# Access Compliance Report

## Public Rights-of-Way

### (Curb Ramps)

Intersection ID: 17268	Main Street: NEW_HAMPSHIRE_DR	Cross Street: SUNFLOWER_RD	Location: NE
ADA ID: F7857FC3F060	Ramp Type: PerpDiag	Initial Pass/Fail: Fail	Overall Compliance: No
Severity Score: 8.75			
Codes/Mitigation Info/Possible Solution		Field Measurements/Component Compliance

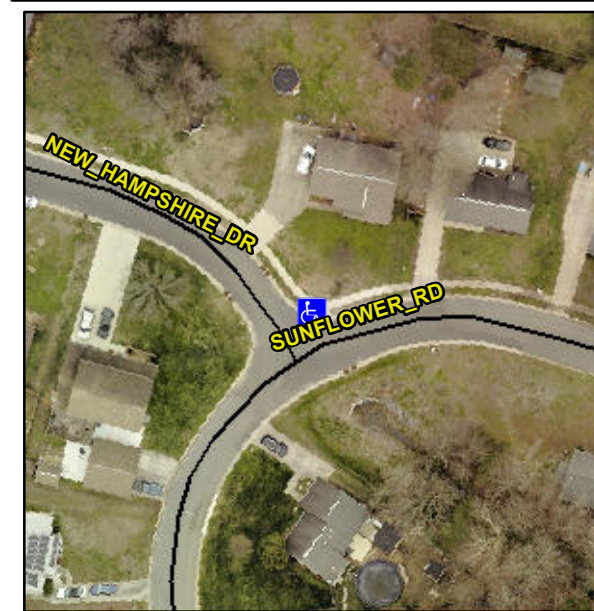
**R304.5.1**

Compliance	Description	Data	Compliance	Description	Data
N/A	Ramp Length (in)	47.0	Yes	Ramp Slope (%)	7.3
No	Ramp Width (in)	41.0	Yes	Ramp XSlope (%)	0.3
N/A	Flare Type LT	N/A	N/A	Flare Type RT	N/A
N/A	Flare Slope LT (%)	N/A	N/A	Flare Slope RT (%)	N/A
N/A	Flare Traversable LT?	N/A	N/A	Flare Traversable RT?	N/A
N/A	Landing Length (in)	N/A	N/A	DWS Provided?	N/A
N/A	Landing Width (in)	N/A	N/A	DWS Contrast?	N/A
N/A	Landing Slope (%)	N/A	N/A	DWS Length (in)	N/A
N/A	Landing X Slope (%)	N/A	N/A	DWS Full Width?	N/A
N/A	Landing Curb? (Y/N)	N/A	N/A	DWS Offset (in)	N/A
N/A	Shared Landing?	N/A			
N/A	Gutter Ponding?	N/A	N/A	Gutter Slope (%)	N/A
N/A	Gutter Lip Ht (in)	N/A	N/A	Gutter X Slope (%)	N/A
N/A	Painted X Walk1?	No	N/A	Painted X Walk2?	No
	X Walk 1 Direction	To NW		X Walk 2 Direction	To SW
N/A	X Walk 1 Width (in)	N/A	N/A	X Walk 2 Width (in)	N/A
	X Walk 1 Slope (%)	0.6		X Walk 2 Slope (%)	0.5
	X Walk 1 X Slope (%)	0.9		X Walk 2 X Slope (%)	0.7

**Remove & Replace Curb Ramp With Two New Directional Ramps or Equivalent.**
